Agenda
Village of Arlington Heights
Zoning Board of Appeals
Buechner Room, 1st Floor
Arlington Heights Village Hall, 33 S. Arlington Heights Rd.
January 8, 2024
7:00 PM

Prepared By: Derek Mach, Planner
Hearing Date: January 8, 2024
Date Prepared: January 3, 2024
Project Title: Leahy Residence
Address: 515 N. Chestnut Ave.

Prepared By: Steve Hautzinger, Design Planner
Hearing Date: January 8, 2024
Date Prepared: January 3, 2024
Project Title: 720 N. Dunton Ave.
Address: 720 N. Dunton Ave.

DETACHED GARAGE - GABLE ROOF
 515 N. CHESTNUT AVE, ARLINGTON HEIGHTS
 LEAHY RESIDENCE

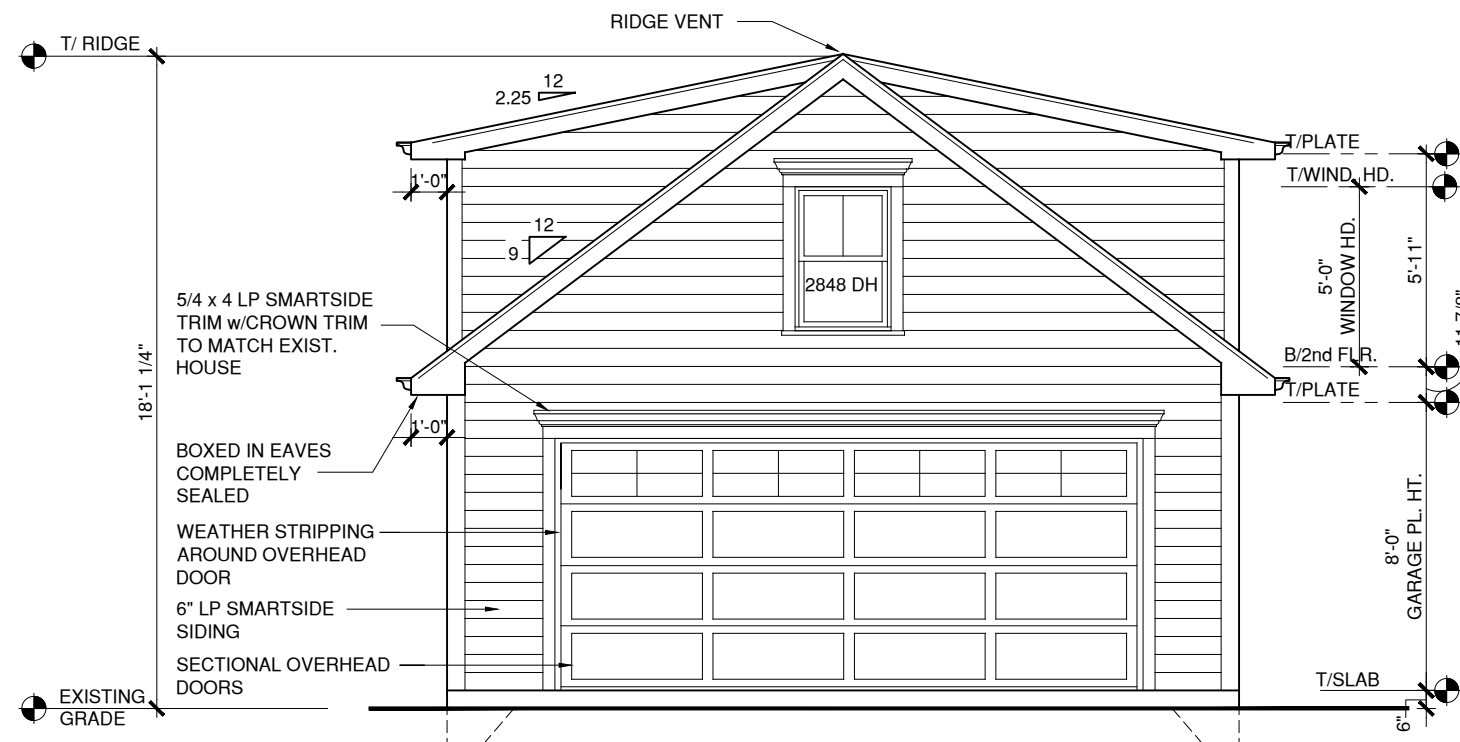
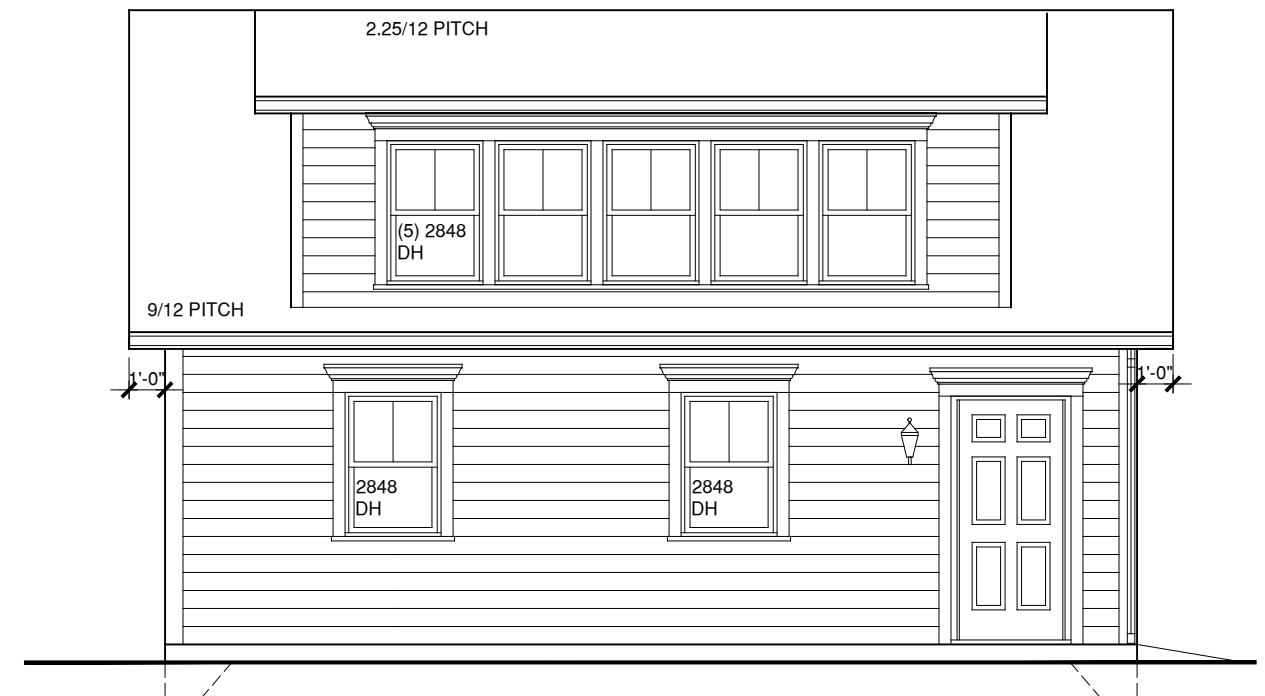
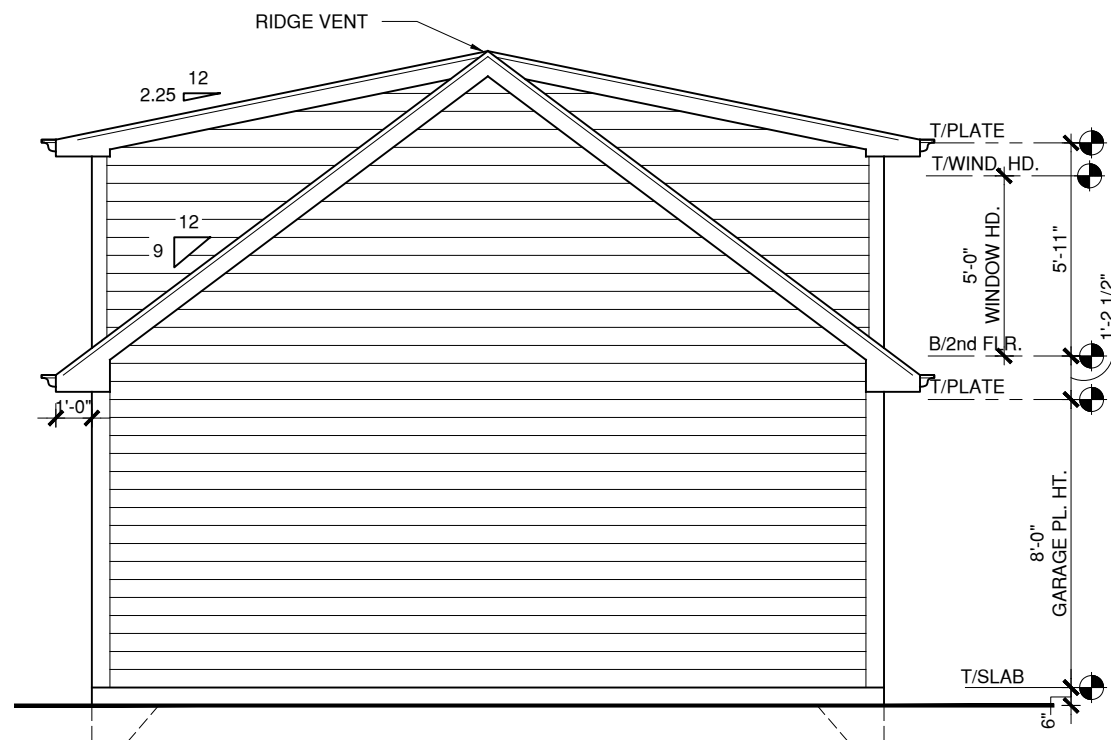
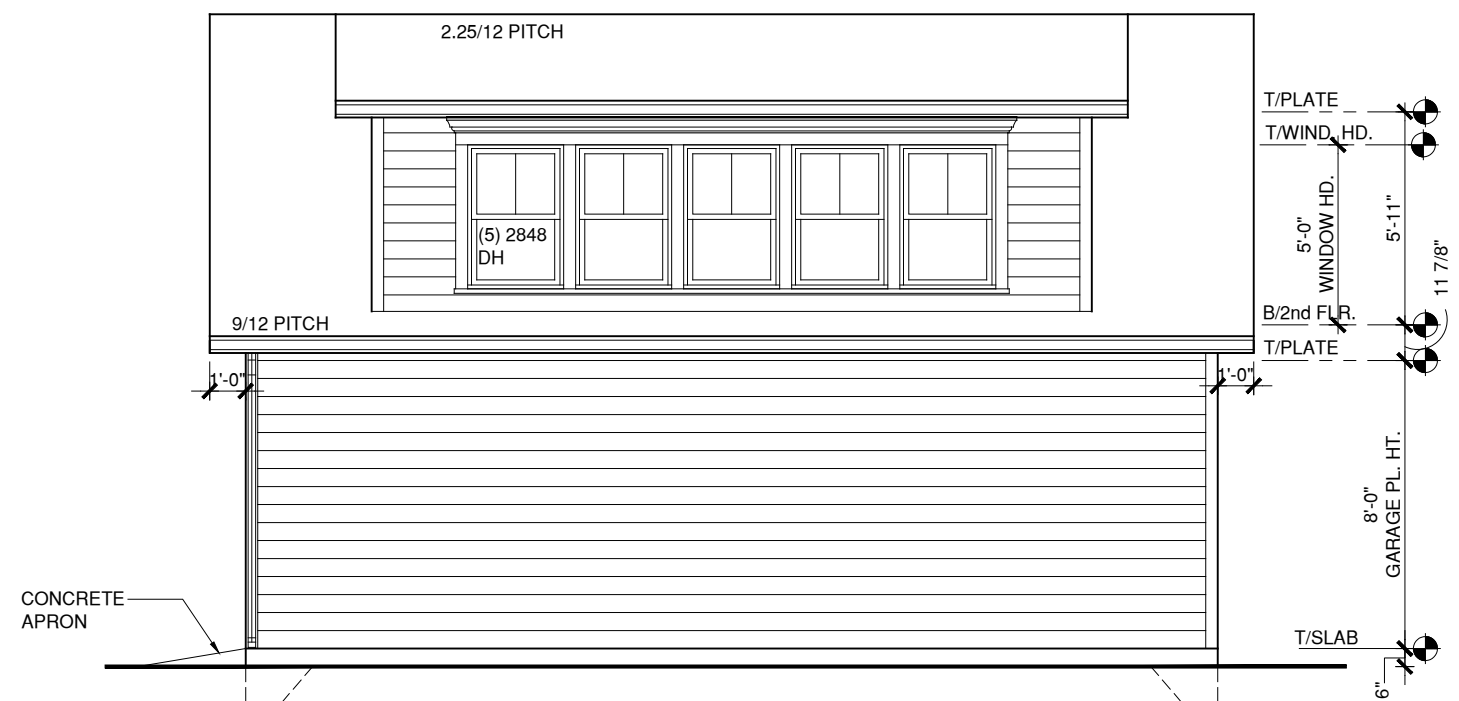
There is no objection to the increased roof pitch and height to match the roof pitch and character of the existing historic house, which is commendable. However, the large dormers on each side of the garage are not necessary to match the architecture of the house which does not have any dormers. The petitioner's explanation does not comment on the the intended use or need for all of the additional garage attic space. If the only goal is to match the architecture of the house, then it is recommended to omit the large dormers.

FRONT ELEVATION - EXHIBIT 1:
APPROVED DESIGN
COMMISSION DRAWING

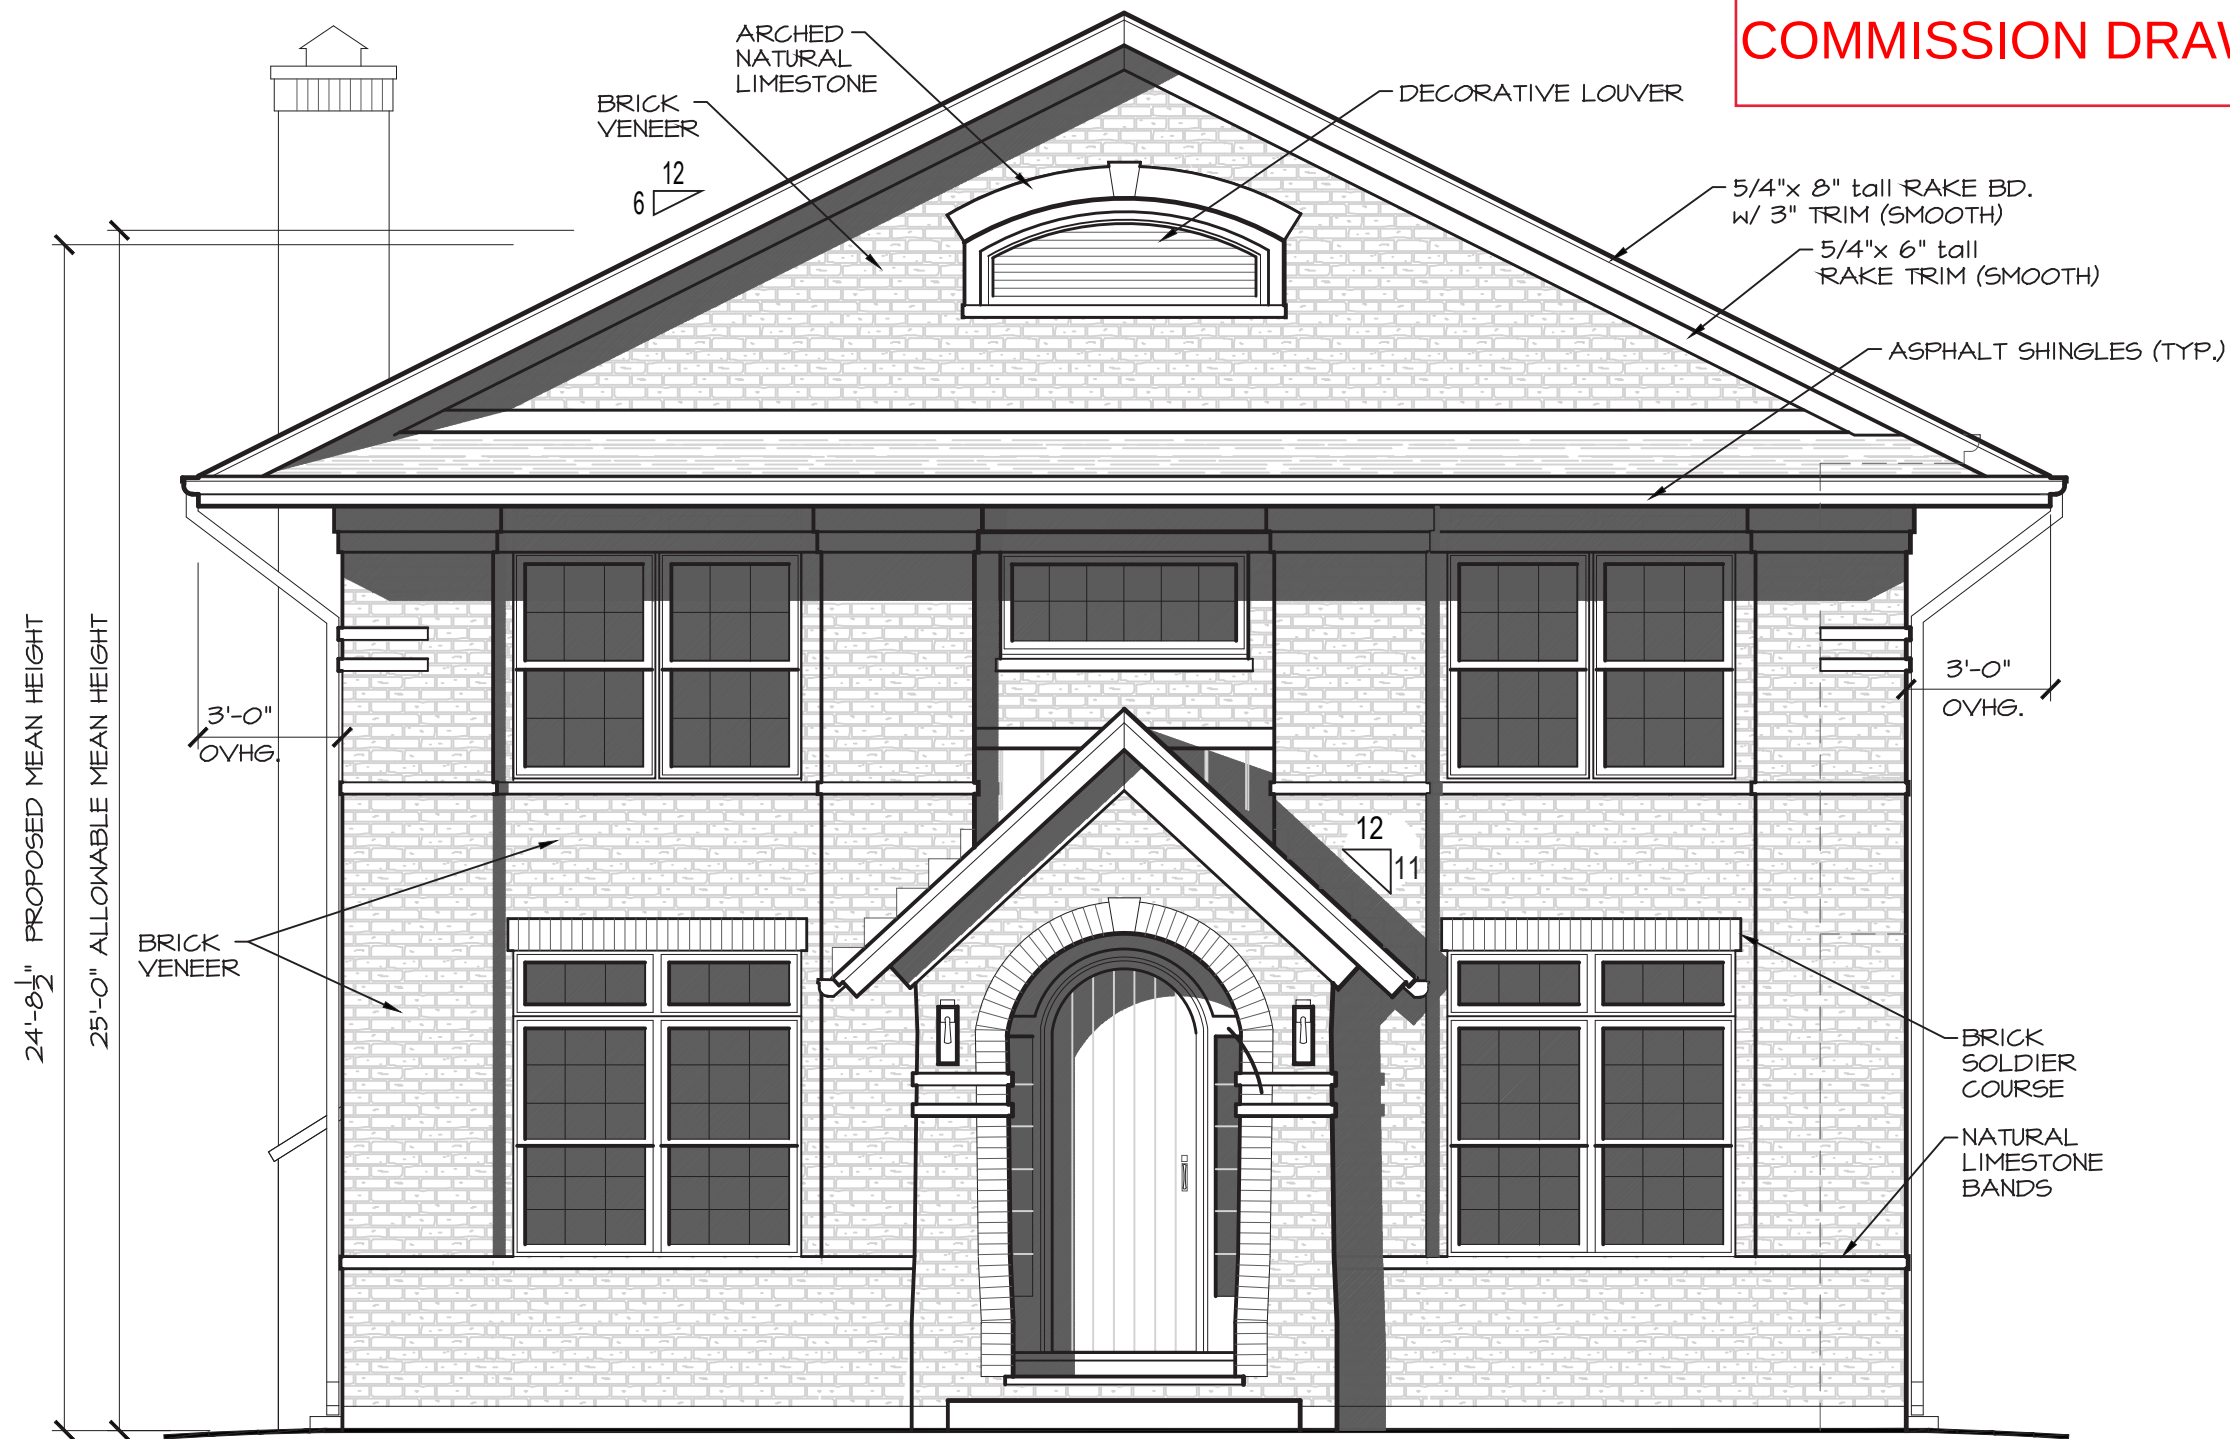
The approved architectural drawings show a level grade around the house with a building height of 24'-8 1/2" with one step up to the front stoop. The architectural plans are not coordinated with the grading plan which shows seven steps up to the front stoop. The height of the house currently under construction either needs to be revised to comply with code, or a building height variation needs to be requested from the Zoning Board of Appeals.
